RE: Final Preferred Project Report 2012 (Revised Concept Plans)
Proposed Expansion of Royal Far West, Manly

MANLY COUNCIL SUBMISSION

SUBJECT: ROYAL FAR WEST EXPANSION CONCEPT PLAN,
SOUTH STEYNE AND WENTWORTH STREET MANLY (MP10_0159)

Critique of RFW Indicative Concept Plan

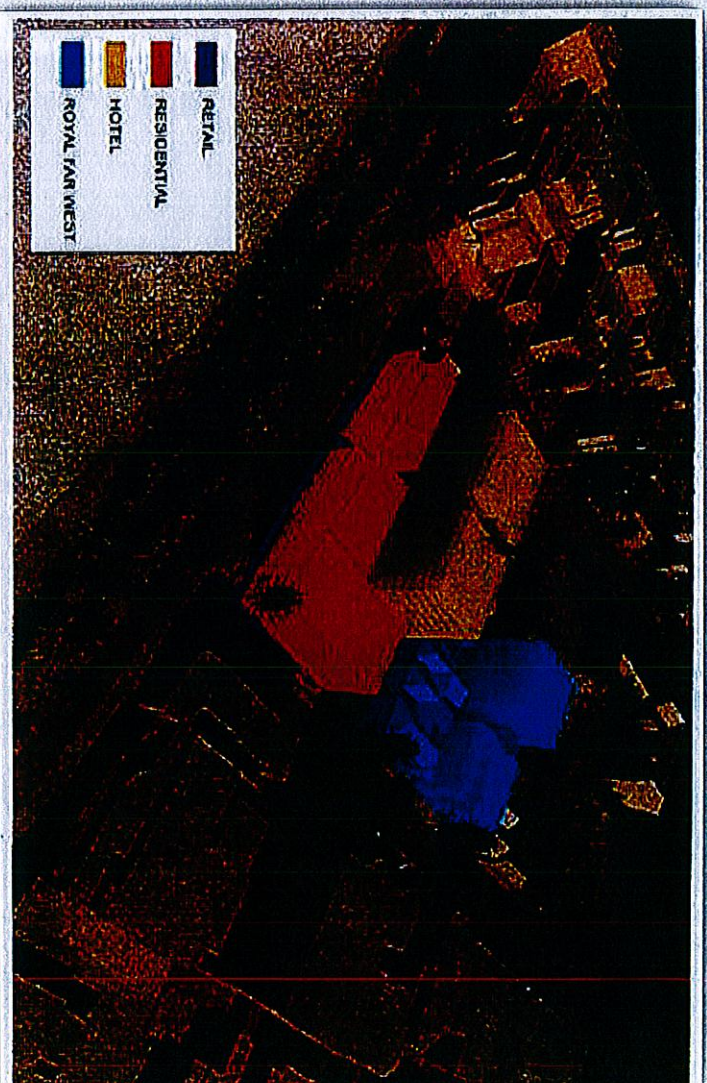
This was the first conceptual massing model /uses RFW submitted under Part 3A. It does not demonstrate consideration of the following as required by Director General:

- Height, bulk and scale within context
- Details of proposed opens space and landscaped areas, interface with public domain, provision of linkages with and between other public spaces.
- Amenity including: Solar access, view loss and wind impacts.
- Transport and assess.
- ESD.
- Heritage.
- Address relevant EPI's including Current and Draft Manly LEP's

DWG No UDF-01(A)

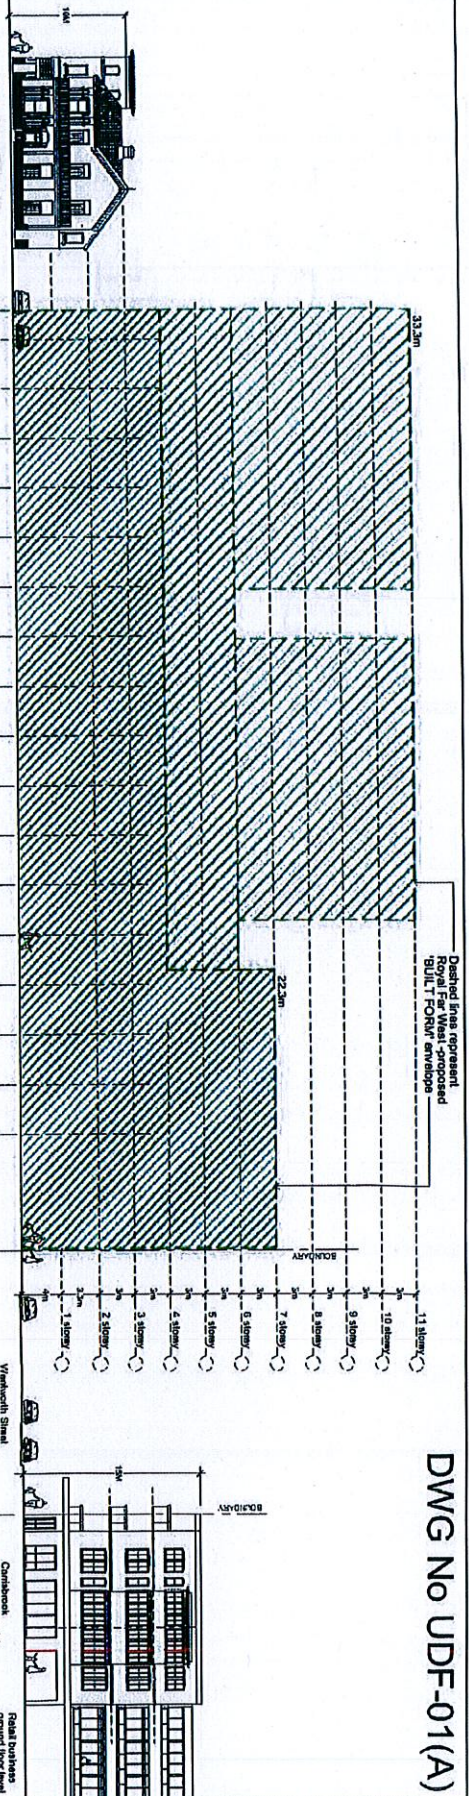
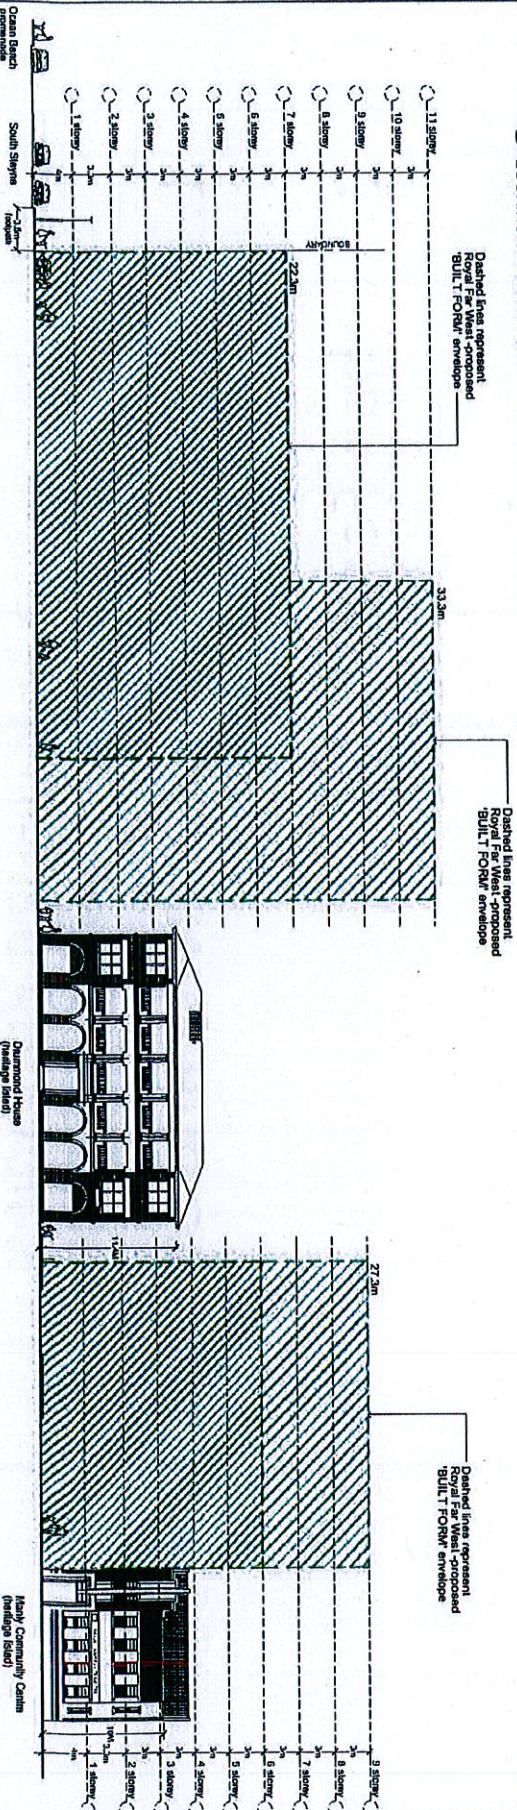
Critique of RFW Concept Plan- Heritage Context

NOTE:
BASED ON AN ASSESSMENT OF THE PART 3A
CONCEPT PLAN RECEIVED BY COUNCIL (ie mp10_0159)
IN LATE 2010 THE ESTIMATE OF THE FSR OF THIS PRO-
POSAL POSAL IS IN THE ORDER OF 3.8:1

COMPARISON b/w RFW Concept + Manly Council Design guidelines wire frame max Building Envelope Control

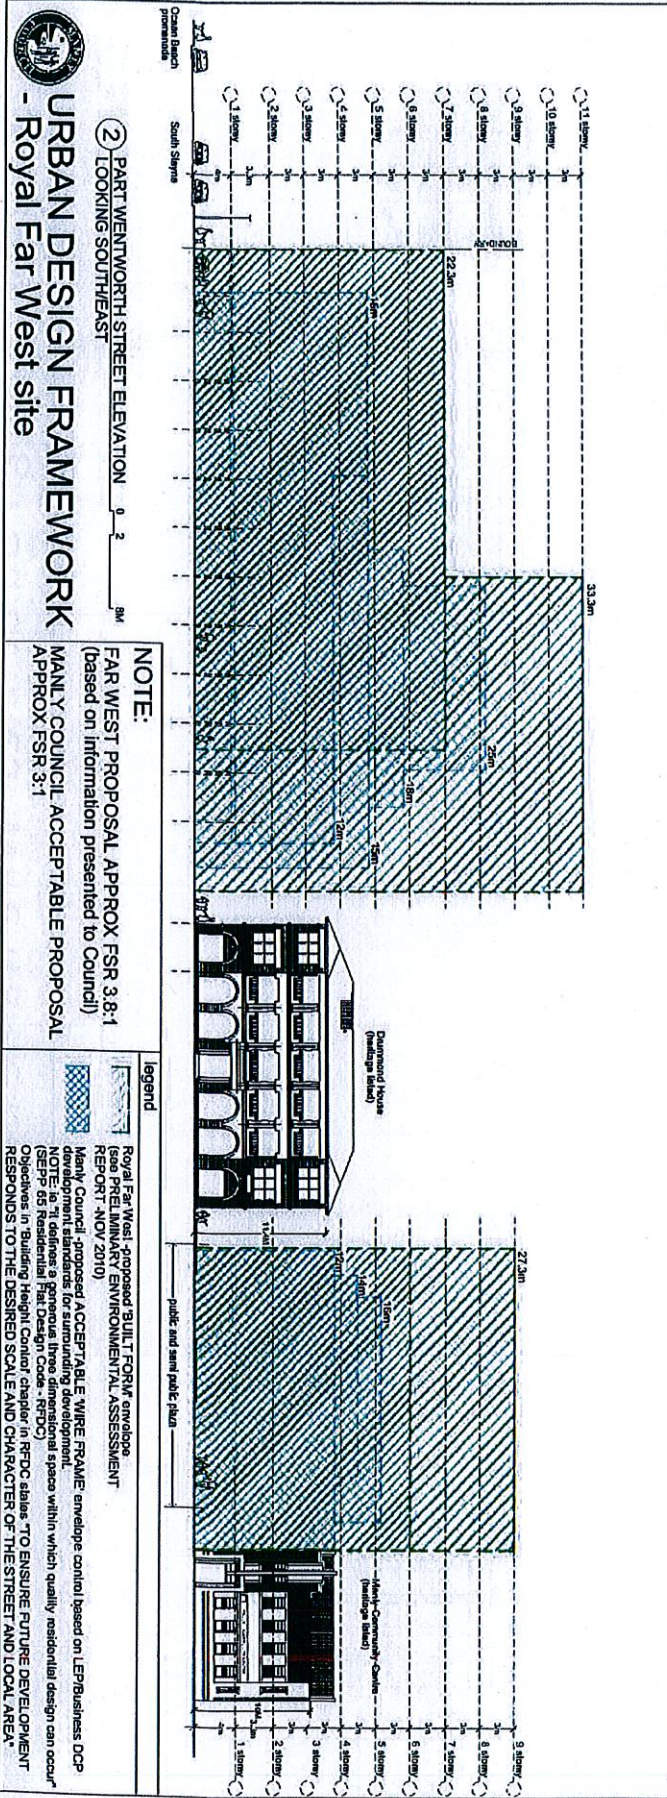
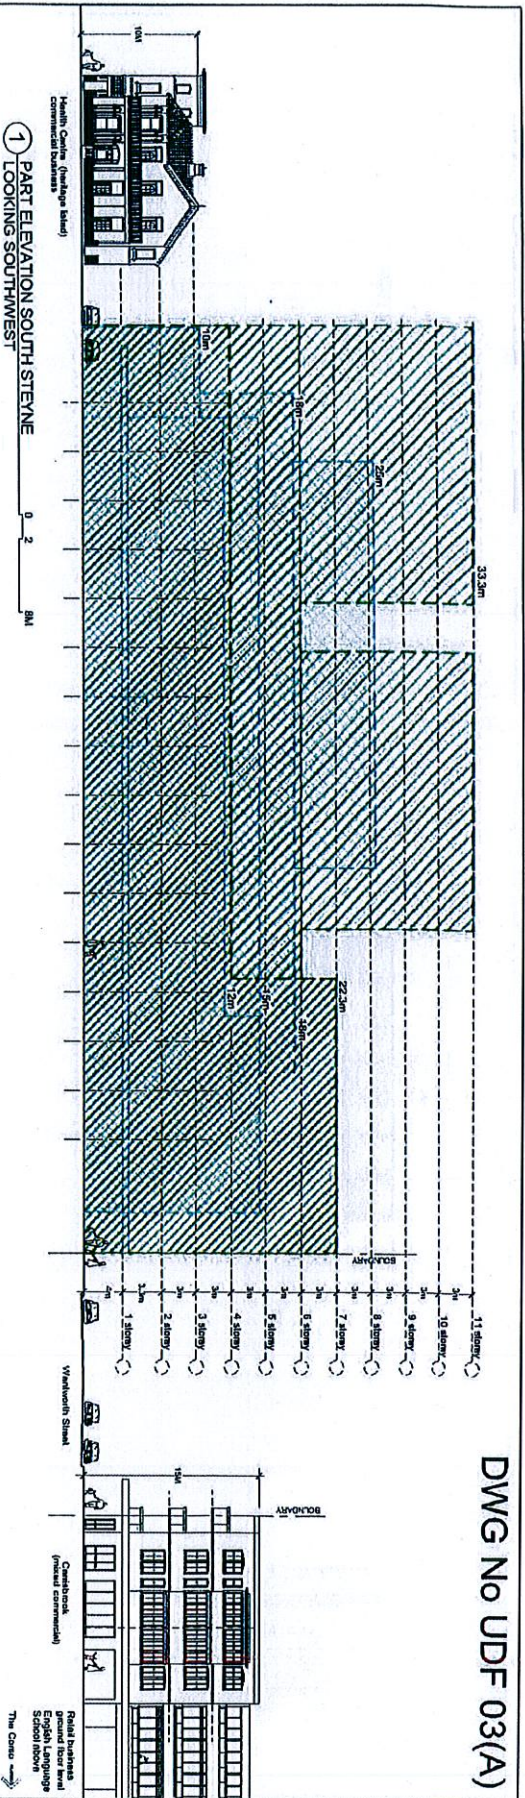
NOTE:
 MASSING MODEL OF MANLY COUNCIL
 ACCEPTABLE WIRE FRAME/
 BUILDING ENVELOPE MAX BUILDING
 HEIGHT CONTROL FOR FAR WEST SITES.
 (shown as dashed lines and hatched-
 heights shown are above footpath level).
 Heights of existing adjoining buildings also shown.
